CRA Urban Design Overlay District- City Staff and Community Comments

CITY STAFF COMMENTS			
Commentator	Referenced Section	Comment	Response
Public Works	2.2-2.4	Is this document going to trump the LDC entirely?	No, the document will not trump the LDC entirely. Where a conflict exists between the Overlay and the underlying land development regulations, the Overlay will prevail. The Overlay will not alter allowable land uses under the current zoning, however, it will, in some instances modify dimensional standards and provide additional clarifying language related to the existing zoning. The Overlay's provisions will be limited to the Urban Core, Westside and Eastside Redevelopment Areas, excluding the City's existing Special Review Districts (SRD's) and the Port of Pensacola.
Public Works	Table 5.4.1.(D)	Tree cannot reduce required width for 5' wide pedestrian path.	Correct, trees cannot reduce the required width for a 5' wide pedestrian path. All ADA regulations must be adhered to. Table 5.4.1.(D) does not supersede ADA, not does any other section of this Overlay.

Table 5.3.1: Detached Single-Family & Duplexes (R-1AA, R-1A)

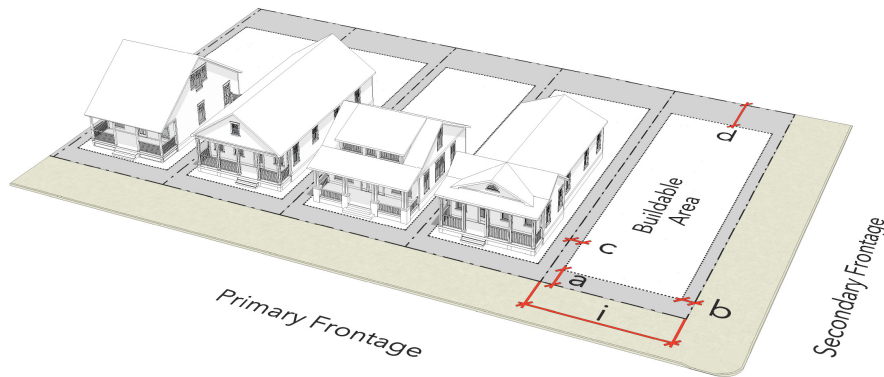
Building Inspections	Table 5.3.1	(Setbacks – Accessory Structures) the minimum side yard setback is 1 foot. Please take into account eave overhangs, water runoff and fire rating requirement of walls.	Discussed in meeting on 3/19. This will permit existing homes to add a porch.
Building Inspections	Table 5.3.2	(Setbacks – Accessory Structures) the minimum side yard setback is 1 foot. Please take into account eave overhangs, water runoff and fire rating requirement of walls.	Discussed in meeting on 3/19. Retaining water on own lot is a requirement. We encourage smaller setbacks for accessory structures given narrow width of many lots. Building code standards will have to be adhered to for fire-rating.
Building Inspections	Table 5.3.5	Define Hybrid Commercial.	Defined.
Building Inspections	5.4.1	Identifies urban design guidelines, but all sections state "shall" which indicates these are in fact standards and not guidelines.	Section removed.

Griffin Vickery	Table 5.3.1	The "Frontage & Lot Occupation" section appears to only be frontage occupation, especially since a lot occupation section follows.	Correct, this has been changed.
Griffin Vickery	Table 5.3.1	The referenced Section 5.6.1 regarding encroachments in note (2) does not appear to be the intended reference regarding principal building height.	Yes, these were updated in subsequent drafts.
Griffin Vickery	Table 5.3.1	There is reference to note (3) in the parking section of the table, but no such note appears.	Yes, these were updated in subsequent drafts.
Griffin Vickery	Table 5.3.1	The illustration would benefit from an accessory building buildable area. If not provided, the lettering of the individual setbacks (e-h) should be discarded.	Correct, this has been changed.
Griffin Vickery	Table 5.3.1	The illustrations would benefit from more realistic and proportional representations of front and rear setbacks (i.e., closer to 4 and 6 times the side setback, respectively).	Correct, this has been changed, with the fixes that were tied to the prior comment.

Griffin Vickery	Table 5.3.1	The illustration would benefit from enlargement to fully utilize the space.	Agreed, the illustrations have been enlarged.
Griffin Vickery	Table 5.3.1	Additionally, it is not necessary to show four different renderings of single-family dwellings – two would be adequate.	Thank you for your comments. We will consider reducing the number of renderings.

Table 5.3.2: Attached Single-Family (Townhouses) (R-1A, R-1B, R-2A)

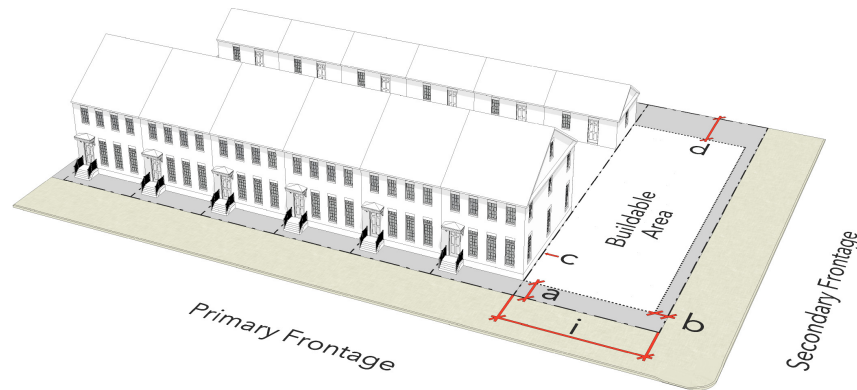
Griffin Vickery	Table 5.3.2	Table 5.3.2: Attached Single-Family (Townhouses) (R-1A, R-1B). The principal building setbacks section of the table indicates a 0 or 5-foot minimum interior side setback. Since these are attached units, the 5-foot is assumed to apply only to an end unit on an interior lot. If so, it would be clearer to separate it in the table section or show a 10-foot separation between two midblock units in the illustration.	Thank you for your comments. We will clarify.
Griffin Vickery	Table 5.3.1/5.3.2	Some of the comments made on these two tables also apply to the other tables of the section. Tables are helpful to summarize information, but if too brief in content they can cause confusion.	We agree. Thank you for your comments.
Griffin Vickery	6.1.1.a	Section 6: Additional Landscape Standards 6.1 Landscape on Private Property In 6.1.1.a, DBH is used to identify the diameter of "trees planted to meet this requirement," but Florida Grades and Standards indicate DBH is not an appropriate measure for nursery trees. It is presumed that those grades and standards are specified in the other landscaping standards to achieve quality tree plantings the City wants. If so, caliper is the standard diameter measure of such trees. If not, I would recommend their adoption as a common reference for all parties in development.	Agreed, we will change from DBH to caliper for standard diameter measurements.

Figure 5.6.2: Encroachment for Arcades & Colonnades Illustrated

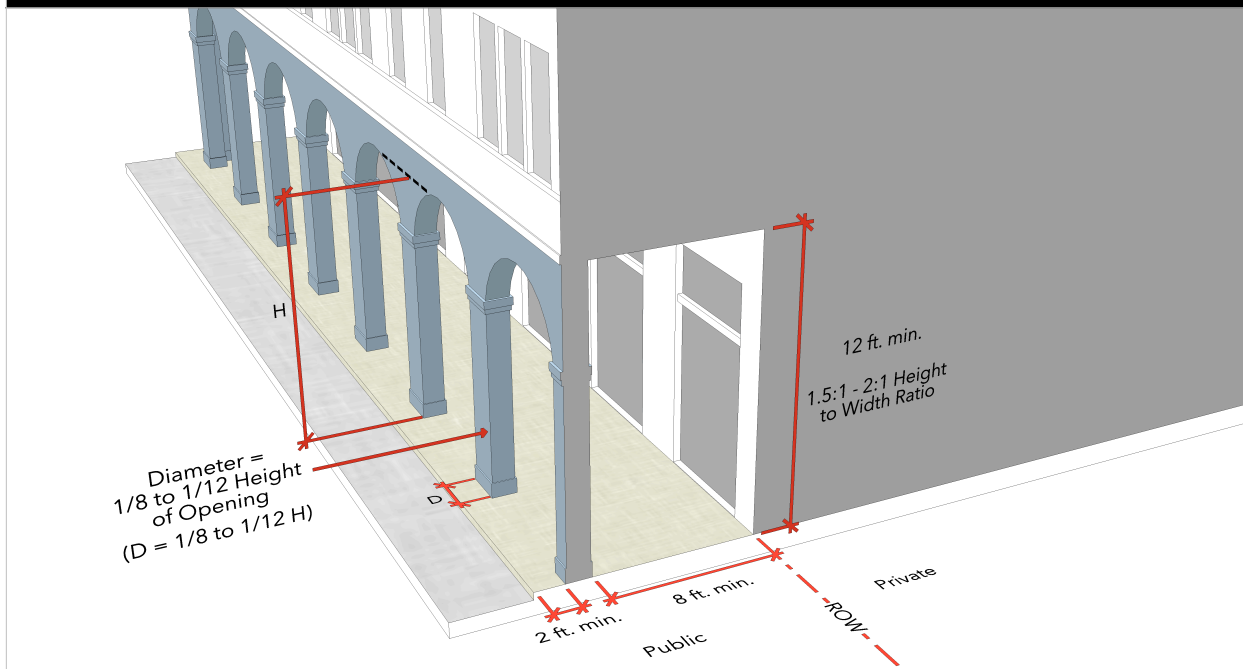
Charles Washington	Table 5.4.1 and Figures 5.6.2 and 5.6.3	Missing Tables or Figures. The draft has several missing (not included) tables or figures. Tables are missing on pages 17 and 18. Figures are missing on page 24.	Thank you for your comments.
Charles Washington	Tables 5.3.1-5.3.5 and Figure 5.6.1	Properly labeling or identifying the contents of a table or tables. See, for example, the table on pages 12, 14, 15, and 23.	Thank you for your comments. We will clarify.
Charles Washington	None Referenced	Substantive Content. 1. Deteriorating and Abandoned Housing. I was very surprised and disappointed that there is not one mention (that I could find) of keeping the CRA area free of deteriorating and abandoned buildings--private residence, commercial building or churches. The absence of such mention is to suggest that the intent is to preserve the area with its historic bight of abandoned and/or deteriorating buildings. This deserves at least a mention if not a policy statement or guideline to prevent such or to eliminate such buildings,	One of the CRA's main purposes is to remove and eradicate blight within the redevelopment areas. We will add a statement to the Intent section of the Overlay establishing that one of the goals of the design standards is to support the removal of blight within the redevelopment areas. The overlay, in and of itself, however cannot remove deteriorating and abandon housing, but it can support redevelopment of such within it's boundaries.

5.7.3. Vehicular parking location is restricted as follows:

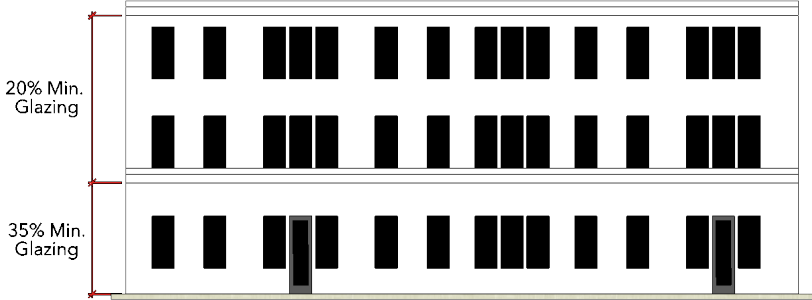
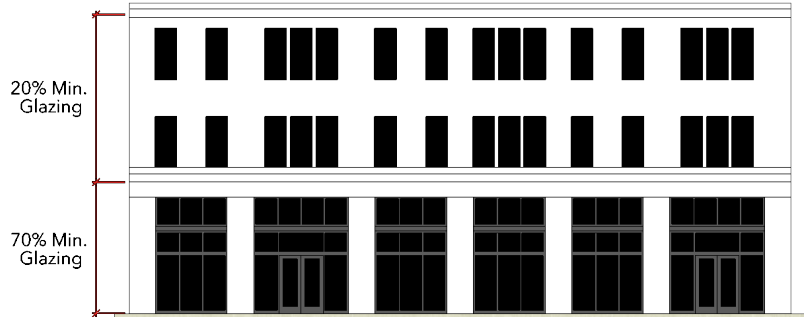
Public Works	5.7.3.a.ii	How do you do this if the lot is 30 ft wide and no on-street parking.	It requires that covered or garage parking be placed towards the back of the lot for theses narrowest of lots to ensure garages do not overwhelm the front yard. Uncovered parking is also permissible.
Public Works	5.7.3.a.iv	LDC requires 42 feet, 20 feet is way to close and will clutter up City right of way. Also poses a safety issue.	Modified language to 42 feet. This makes circular driveways for single-family lots not possible. Not a bad thing!
Public Works	5.7.3.a.vi	Shared driveways are not good. They're contradicting themselves in iv and vi.	No contradiction. Shared driveways are encouraged not required.
Public Works	5.7.3.b.i	How is this going to be enforced after the building is built and they park in front of the house?	For multi-family buildings, off-street parking cannot be provided in the front yard. If the front yard is not designed as a parking lot it should be simple This is an enforcement issue.
